**COUNCIL ASSESSMENT REPORT**  
LIVERPOOL LOCAL PLANNING PANEL

<b>PANEL REFERENCE &amp; DA NUMBER</b>	PPSSWC-662 – DA-390/2025
<b>PROPOSAL</b>	Demolition of existing structures, construction of a multi-use community center, including a place of public worship, a 118 children’s center-based childcare facility, an educational establishment, and an indoor recreational facility. The proposal consists of a total of 202 parking spaces with ancillary development, including a canteen, storage, and office space
<b>ADDRESS</b>	315 Fourteenth Avenue, Austral NSW 2179 Lot 6 DP 30409
<b>APPLICANT</b>	PLANZONE Pty Ltd
<b>OWNER</b>	AUSTRAL PROPERTY 1 PTY LTD
<b>DA LODGEMENT DATE</b>	2 September 2025
<b>APPLICATION TYPE</b>	Development Application
<b>REGIONALLY SIGNIFICANT CRITERIA</b>	Clause 5(b), Schedule 6 of <i>State Environmental Planning Policy (Planning Systems) 2021</i> : Private infrastructure and community facilities over \$5 million – development for the purposes of child care centres, community facilities, educational establishments, or places of public worship.

<b>RECOMMENDATION</b>	Refusal
<b>DRAFT CONDITIONS TO APPLICANT</b>	NO
<b>SCHEDULED MEETING DATE</b>	9 March 2026
<b>PLAN VE

**Figure 9: Childcare Centre Landscape Plan**

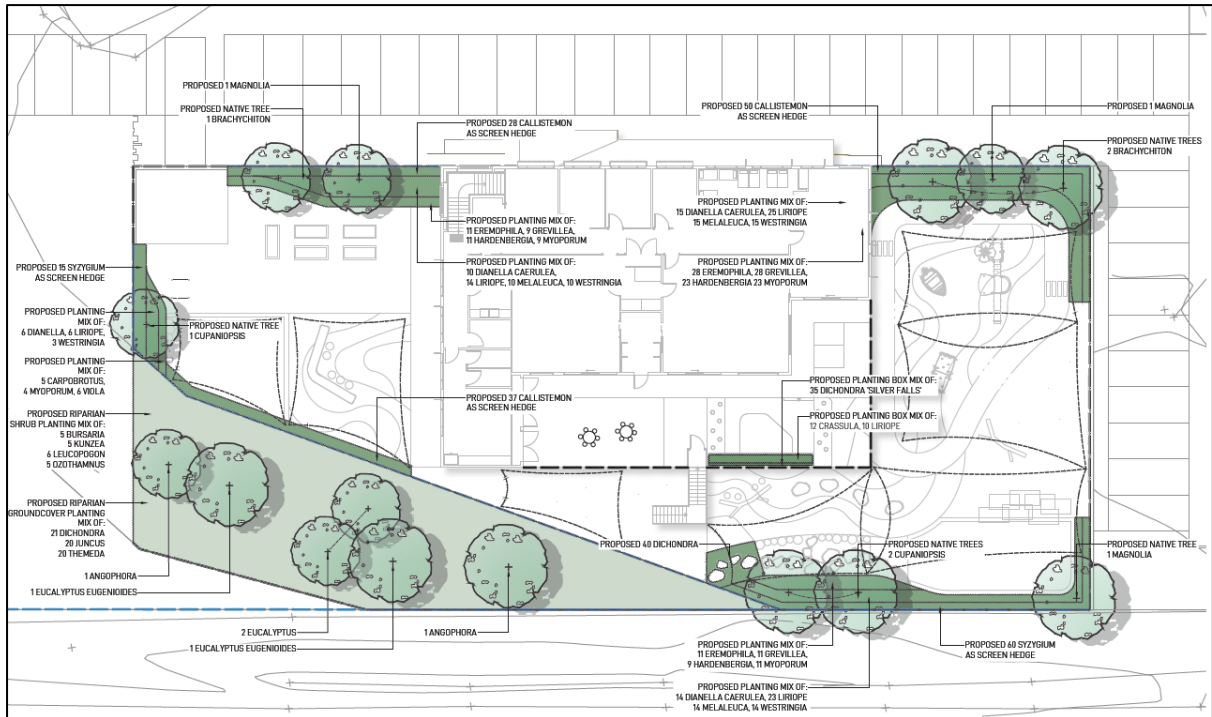
Furthermore, there are inconsistencies between plans as to the proposed fencing throughout. The provided Landscape Plan illustrates a 1.2m rural fence to the south-western perimeter of the outdoor unencumbered space and a privacy fence to the southern perimeter. This conflicts with the provided Statement of Environmental Effects (SEE) in which it is stated that a 2.1m timber lapped and capped boundary fence is proposed around the outdoor play area. The Acoustic Report also makes recommendations for 1.5m fencing that is not illustrated on the relevant Landscape or Site Plans.

A separate Fencing Strategy Plan should be submitted. The plan should identify the location, height, material, and level of transparency of all fences. Detailed sections and elevations should also accompany the plan.

**Figure 13:** Proposed signage along southern elevation.

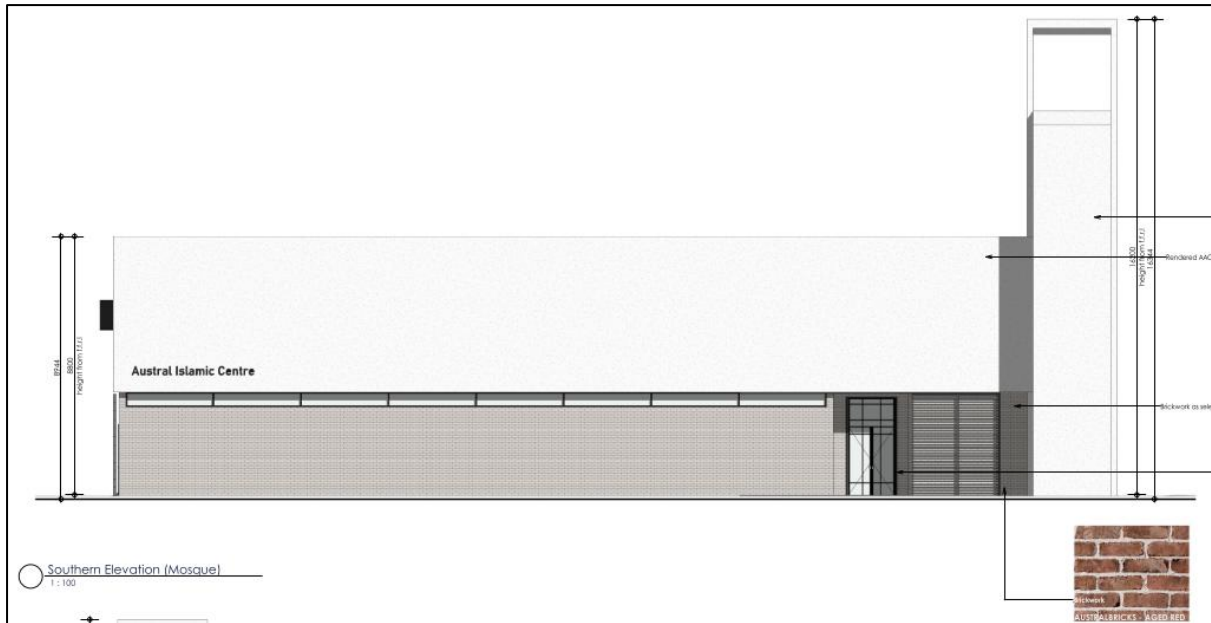
The only signage indicated on the Architectural Plans relates to the Mosque, in which business identification signage states “Austral Islamic Centre”.

**Figure 15: DCP Road Network - Indicative Layout Plan (Source: Geocortex)**

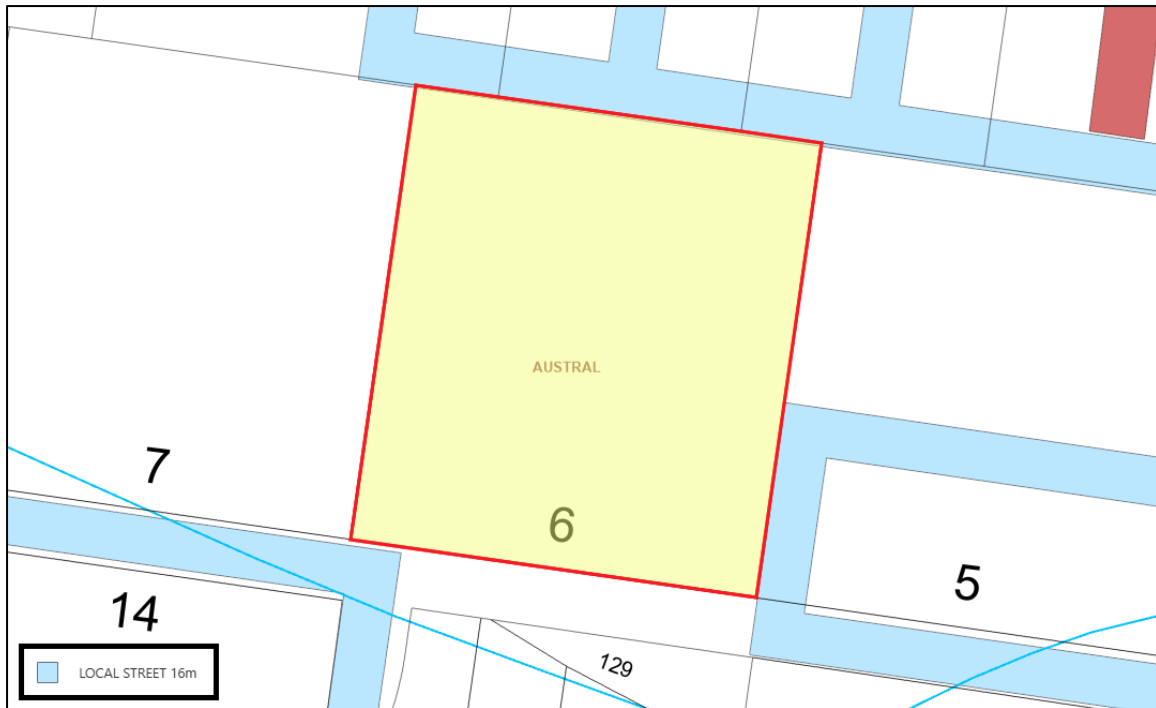
The submitted Civil Engineering plans, illustrate two vehicle crossovers to the neighbouring site to the east, being 295 Fourteenth Avenue, Austral. The DCP Indicative Layout Plan (ILP) indicates an east-west future Local Street (identified as Buwura Crescent in the provided Traffic Impact Assessment) on the neighbouring site. The connection between the proposed

crossover locations and Buwura Crescent is inconsistent with the ILP, and it has not been demonstrated that the proposal is consistent with the Precinct Planning vision for Austral & Leppington North. Furthermore, the application relies on the provision of this future street which is the subject of a separate, undetermined, development application (DA-345/2025).

**Figure 16: Extract of Temporary Access Plan (Source: Colliers)**

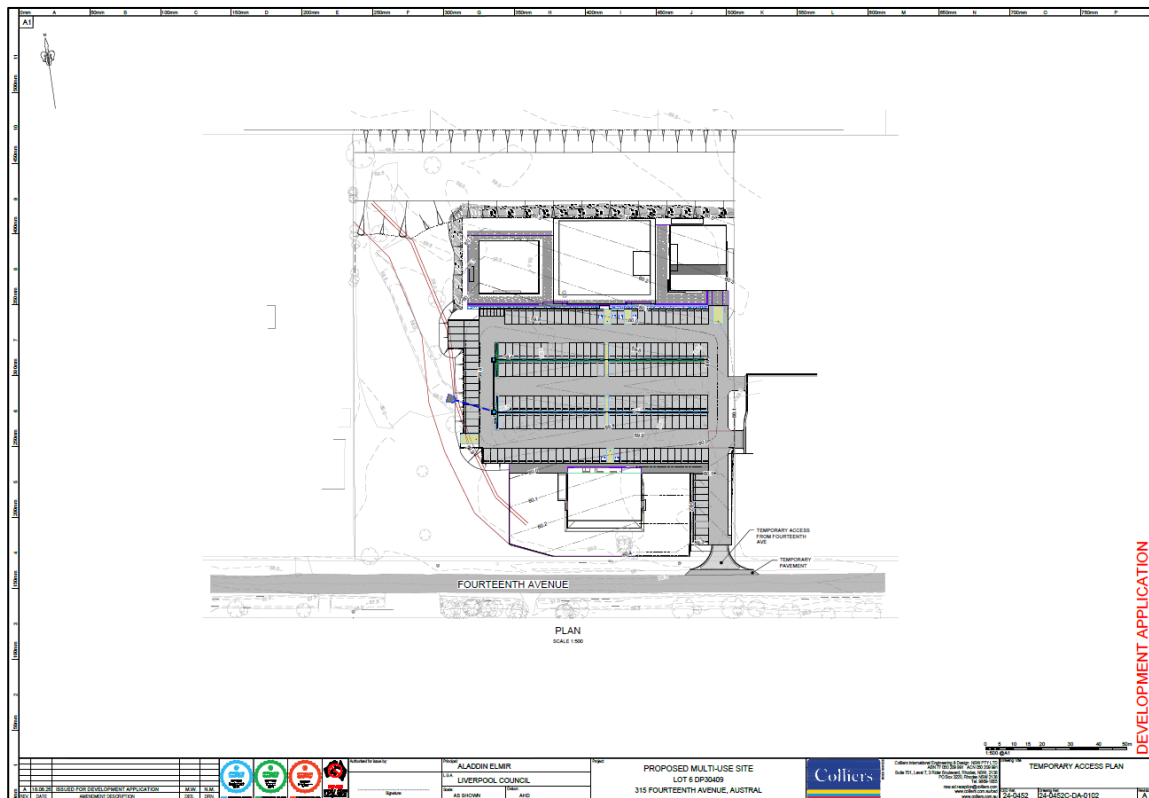
The submitted Civil Engineering plans, indicate that access from Fourteenth Avenue is to be 'temporary' with the existing driveway identified for demolition. Given that access from the site to the east is not yet available this access is not considered temporary. Access from Fourteenth Avenue may be retained as the primary entry point with the connection to the neighbouring site the subject of a future development application or deferred commencement condition.
